CITY OF LOS ANGELES
INTER-DEPARTMENTAL CORRESPONDENCE

3600 W. Wilshire Blvd.
DOT Case No. CEN 16-44880

From: Wes Pringle, Transportation Engineer
Department of Transportation

Subject: **TRAFFIC IMPACT ASSESSMENT FOR THE PROPOSED MIXED-USE PROJECT LOCATED AT 3600 WEST WILSHIRE BOULEVARD (ENV-2016-3413-EAF /CPC-2016-3412-VZC-HD-MCUP-ZAA-SPR /VTT-74412)**

Figure 1B
Site Plan

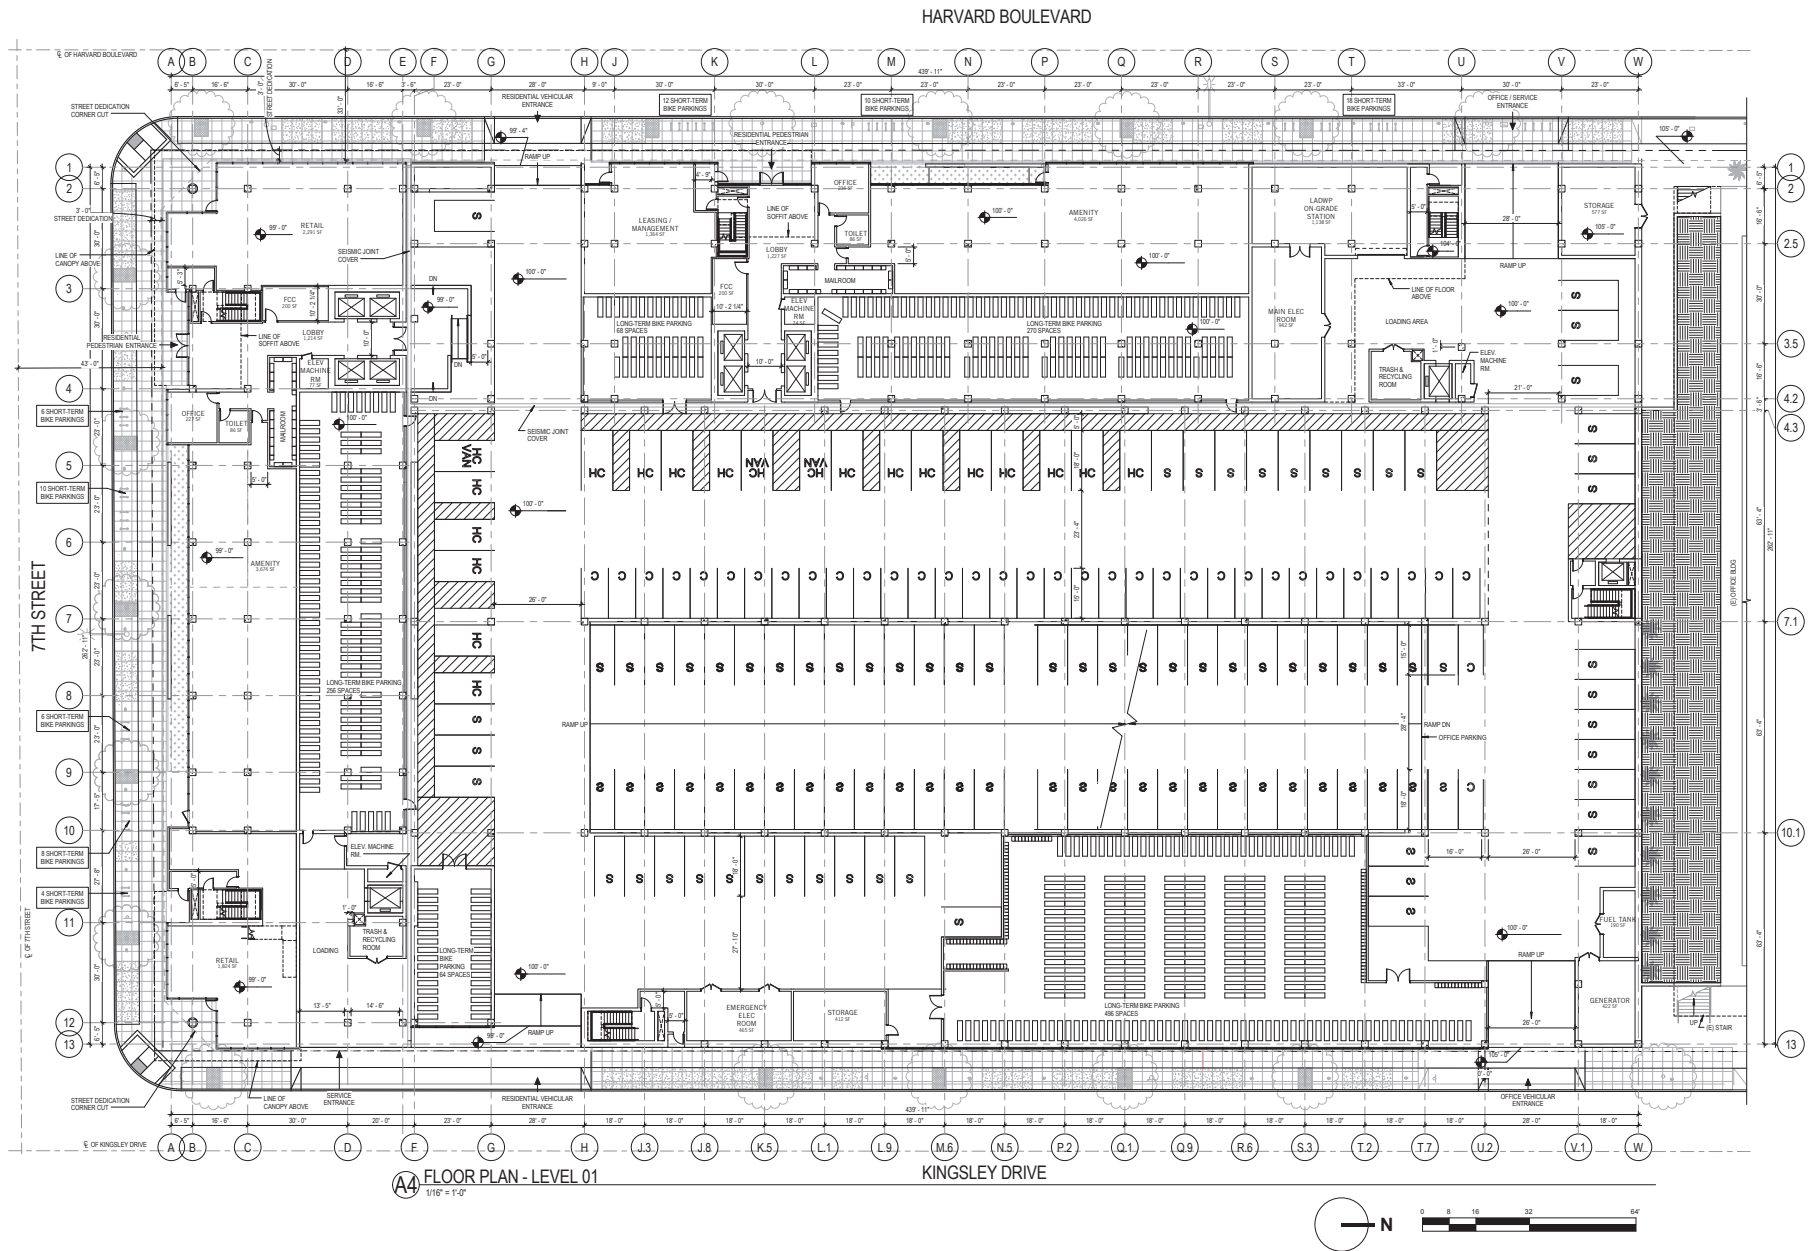
The conceptual site plan (**Attachment 2**) is acceptable to DOT. However, the review of this study does not constitute approval of the driveway dimensions, access and circulation scheme. Those require separate review and approval and should be coordinated with DOT's Citywide Planning Coordination Section (201 N. Figueroa Street, 5th Floor, Room 550, at 213-482-7024). In order to minimize and prevent last minute building design changes, the applicant should contact DOT for driveway width and internal circulation requirements so that such traffic flow considerations are designed and incorporated early into the building and parking layout plans. All driveways should be Case 2 – designed with a recommended width of 30 feet for

two-way operations or 16 feet for one-way operations or to the satisfaction of DOT. Any security gates should be a minimum of 20 feet from the property line or to the satisfaction of DOT. Delivery truck loading and unloading should take place on site with no vehicles having to back into the project via the proposed project driveways.
